**DEPARTMENT OF TOXIC SUBSTANCES CONTROL**REGION 2  
700 HEINZ AVE., SUITE 200  
BERKELEY, CA 94710-2737

**REMEDIAL INVESTIGATION/FEASIBILITY STUDY AQUIFER TESTING  
WORKPLAN, APRIL 11, 1995, NAVAL AIR STATION, ALAMEDA**

**Subject:** Naval Air Station Alameda - Aquifer Testing Workplan

**SITE 1 -  
PROPOSED AQUIFER TEST WELL LOCATIONS**

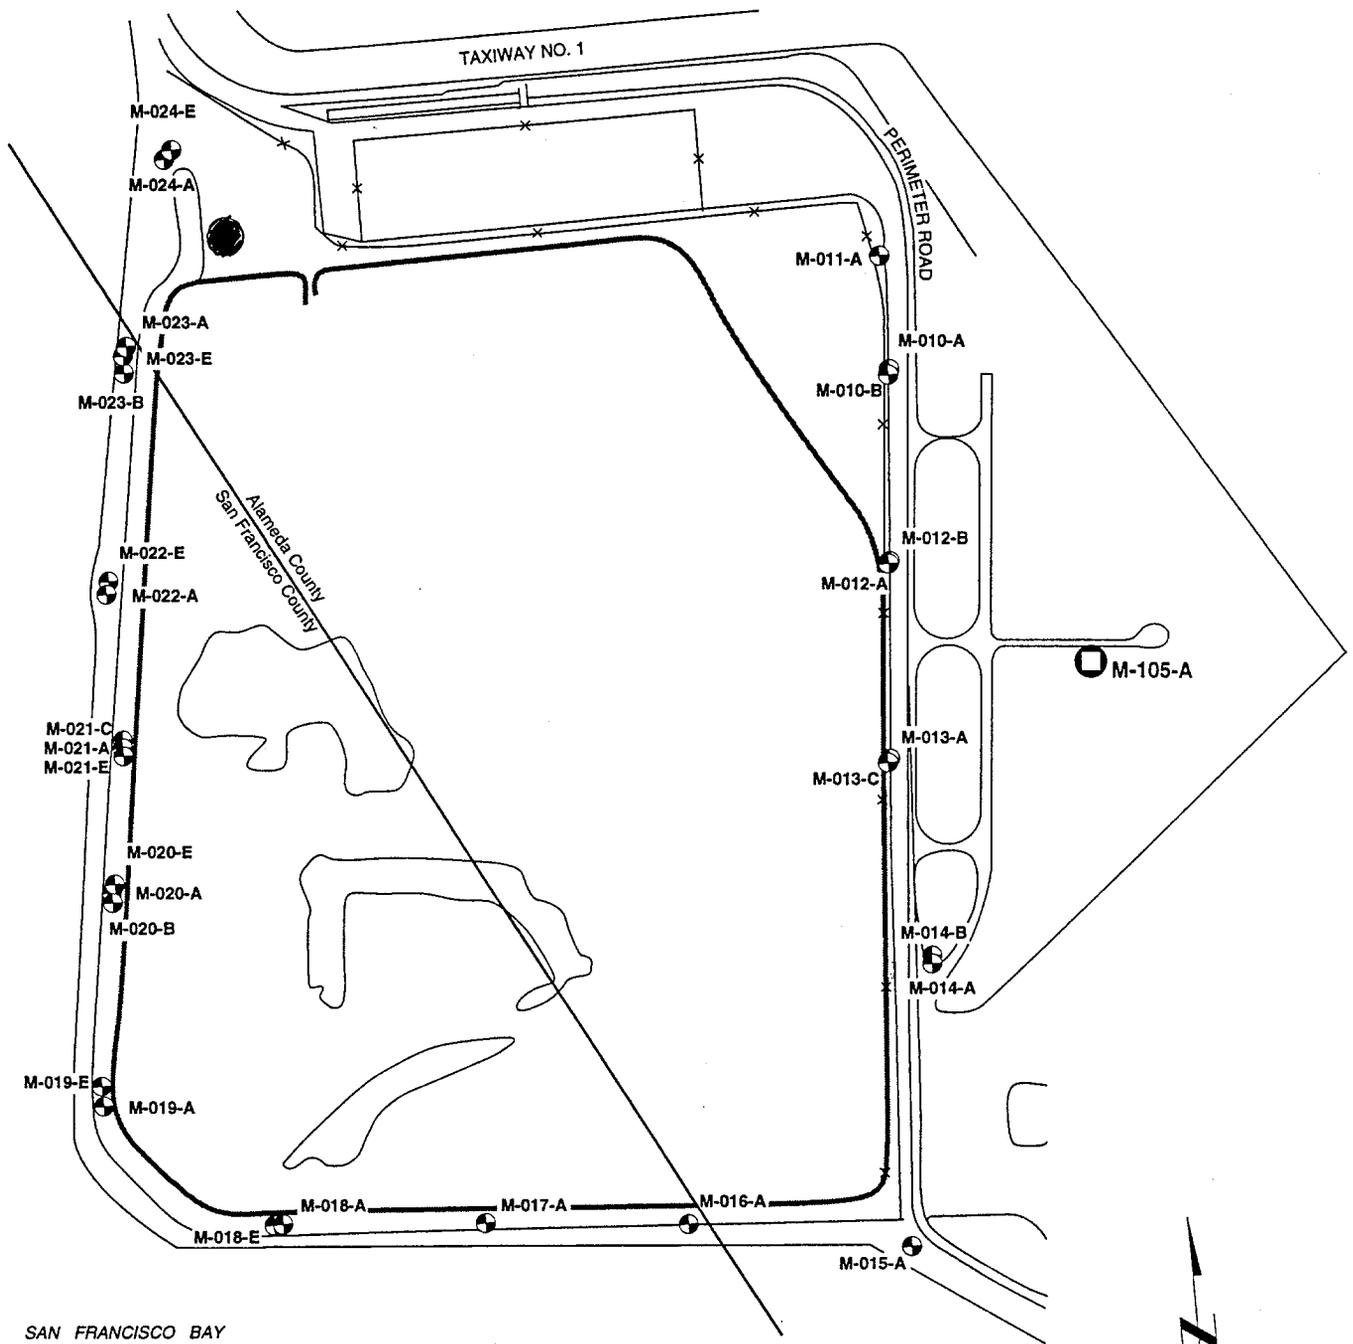
The proposed pumping well number M-031-E is only screened in the bottom portion of the first water bearing zone. The entire length of the aquifer should be screened (zones A through E). For minimum optimal distances for placement of observation wells see recommendations in Driscoll, 1986.

- Monitoring Well Location
- ⊕ Well Cluster (A, E, B, and C Wells) Location
- ⊙ Deep Monitoring Well Location
- ⊕ Shallow Monitoring Well Location
- Proposed Pumping Well
- DTSC's recommendation for pumping well

NAVAL AIR STATION ALAMEDA  
 ALAMEDA, CALIFORNIA  
**SITE 2**  
**PROPOSED AQUIFER TEST WELL LOCATIONS**

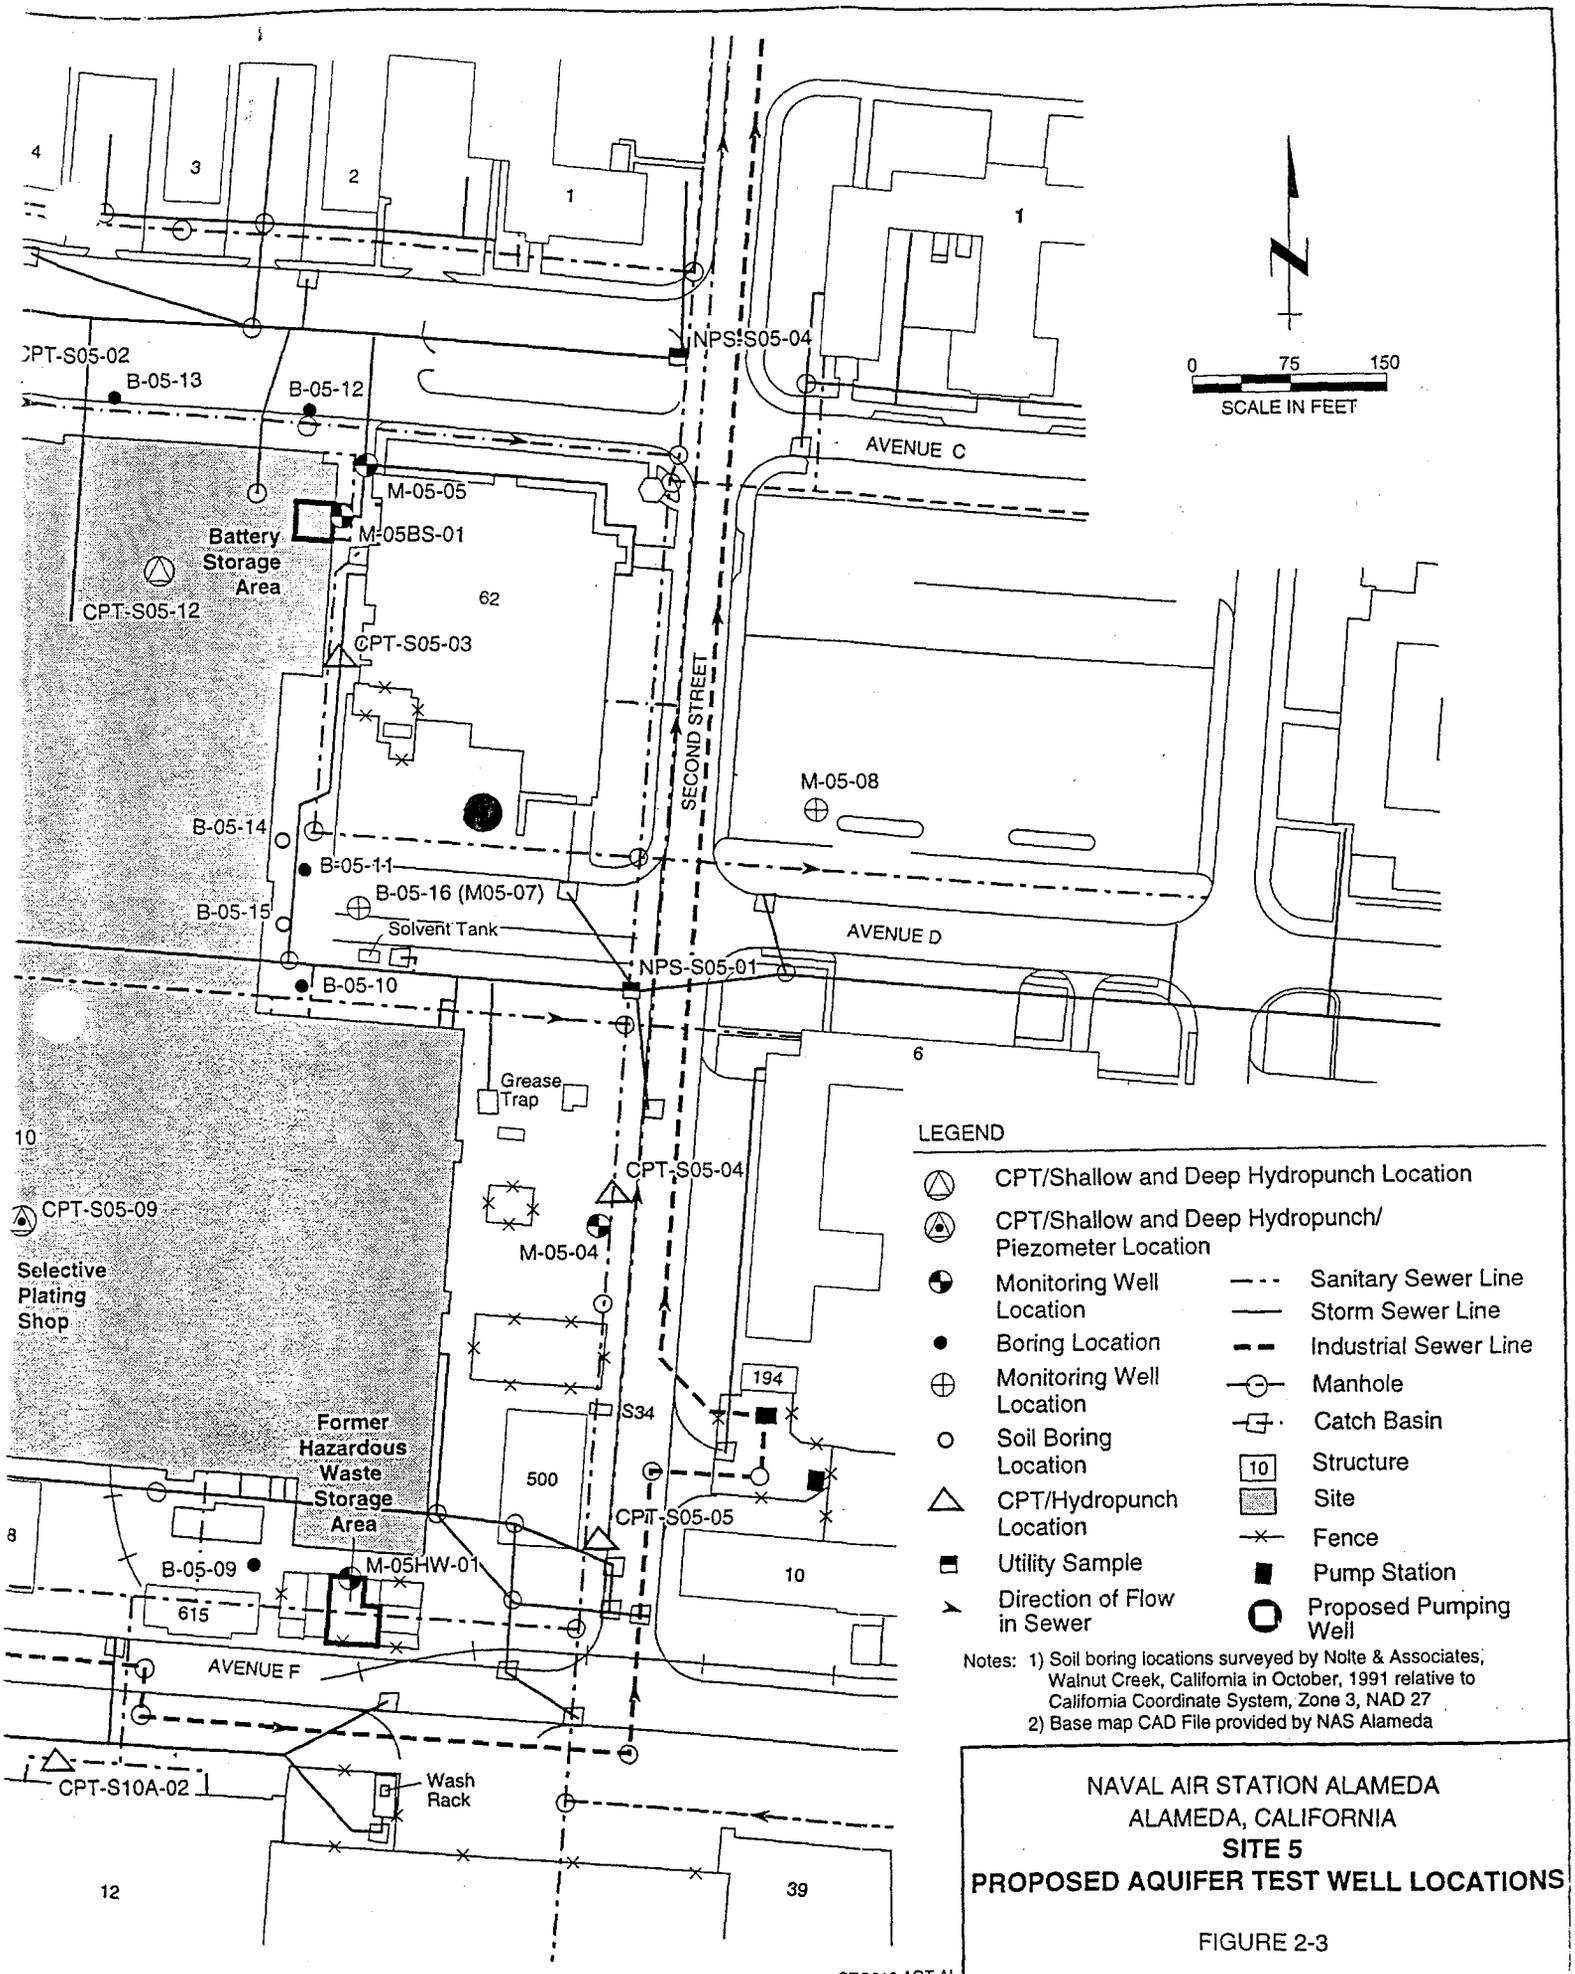
- ⊕ Monitoring Well Location
- ◻ Proposed Pumping Well
- DTSC's recommended location for pumping well
